Subject: Comments on the September 29, 2011, Class II Permit Modification Request: "Update Ventilation Language, Addition of a Shielded Container, and Revise the WIPP Groundwater Detection Monitoring Program Plan"

Comments on the September 29, 2011, Class II Permit Modification Request

Permittees' Comments on the Class 2 PMRs, "Update Ventilation Language, Addition of a Shielded Container, and Revise the WIPP Groundwater Detection Monitoring Program Plan" Submitted to the NMED on September 29, 2011

Figure L-5
Culebra Freshwater-Head Potentiometric Surface

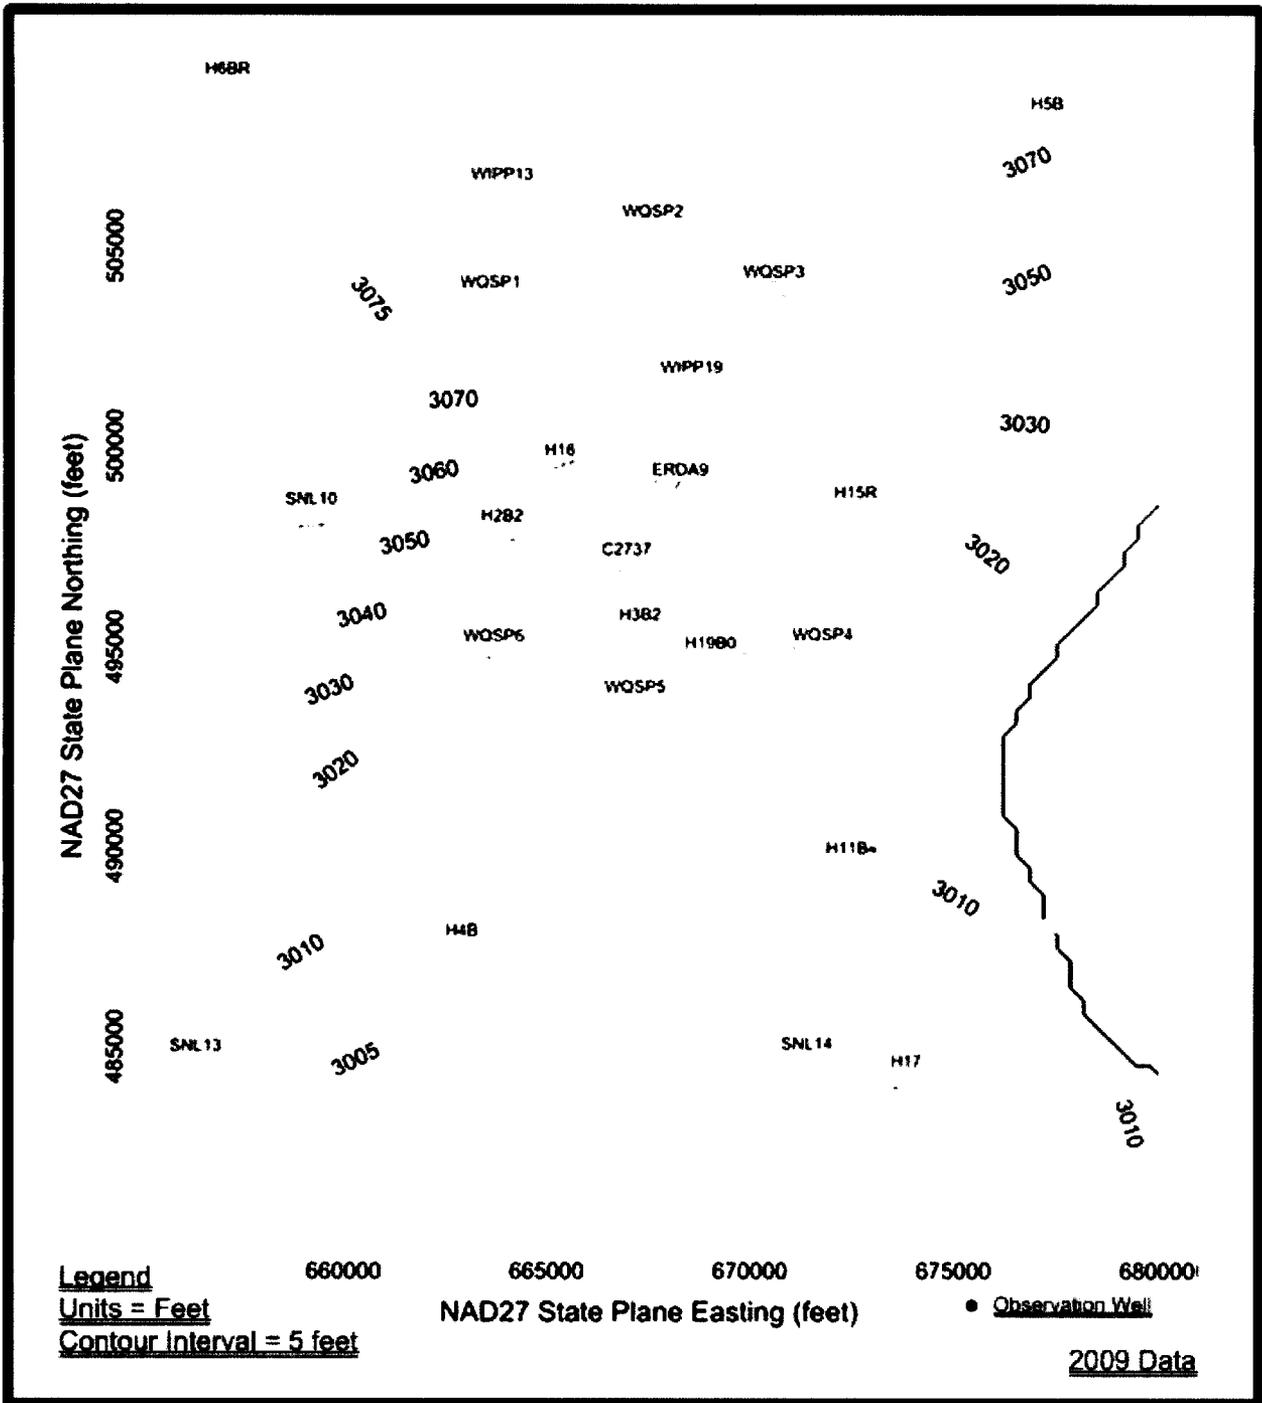
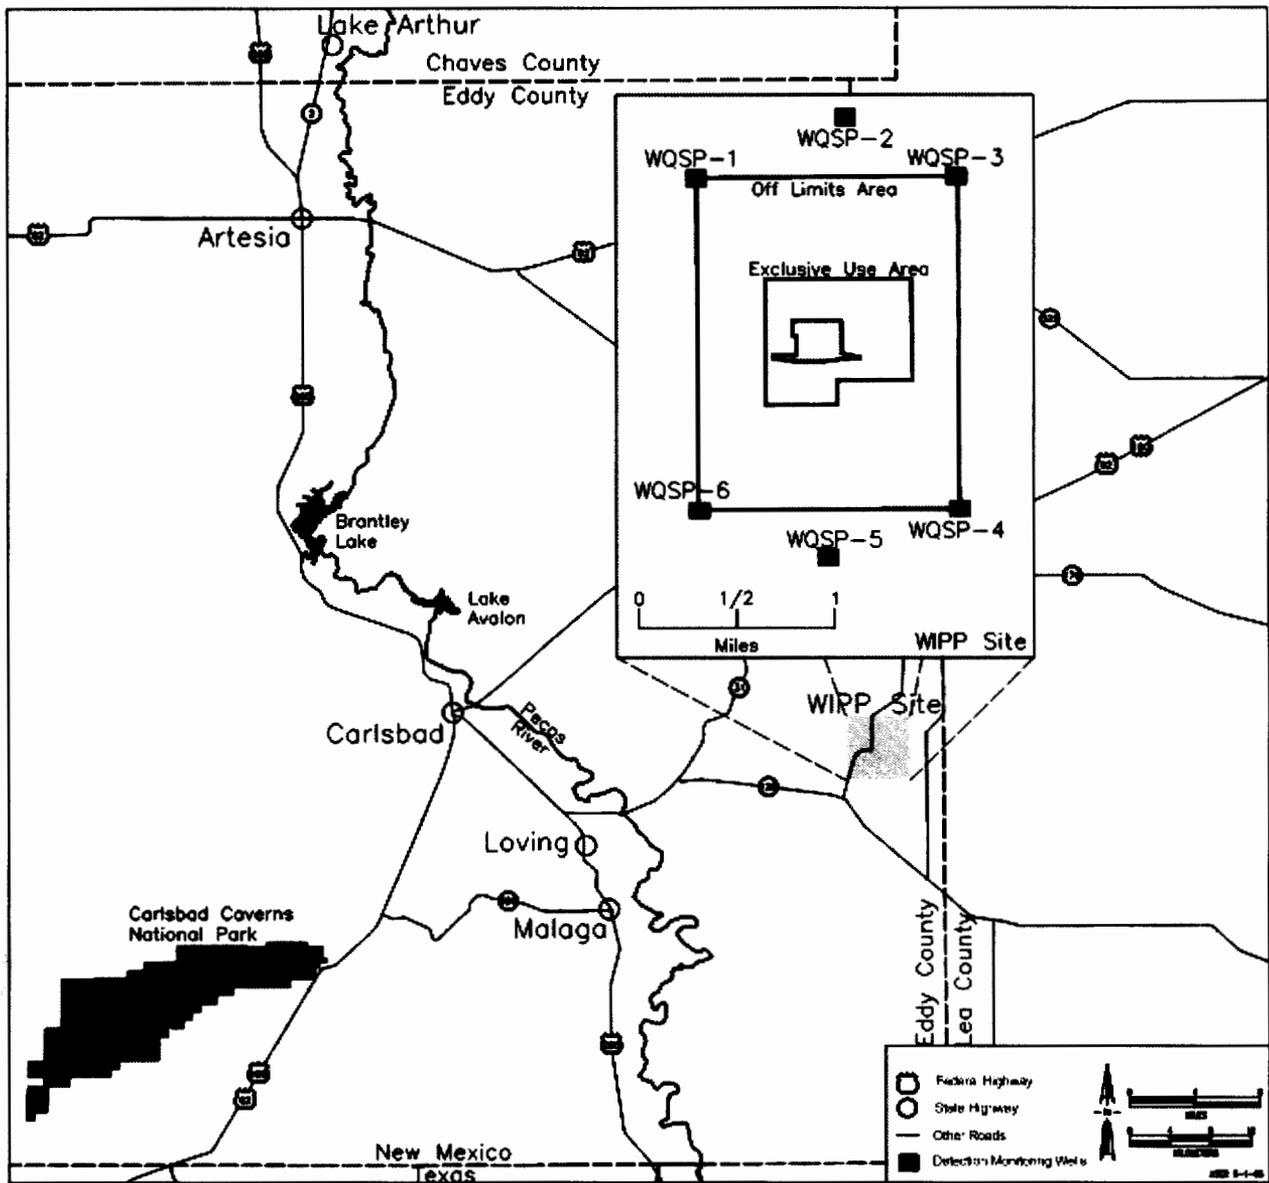
6. Revised Table L-5, Page B-68, to correct table values so they match the values in the figures. Some editorial changes, such as rounding of numbers, were also made. Corrections are highlighted in yellow.
7. Editorial correction to delete the word "Suggested" from the title of Table L-6 in the Table of Contents, PMR page B-12, as it is not in the title of the associated table.
8. Editorial change to Figure L-4, *Generalized Stratigraphic Cross Section Above Bell Canyon Formation at WIPP Site*, to apply the correct color of sand and sandstone to the surficial deposits on the illustration.
9. Editorial change to Figure L-5, *Culebra Freshwater-Head Potentiometric Surface*, to add a legend item to identify the green dots on the potentiometric map as observation wells.
10. Editorial change to delete the acronym "WQSP" from the title of Figure L-6, *Detection Monitoring Well Locations*.
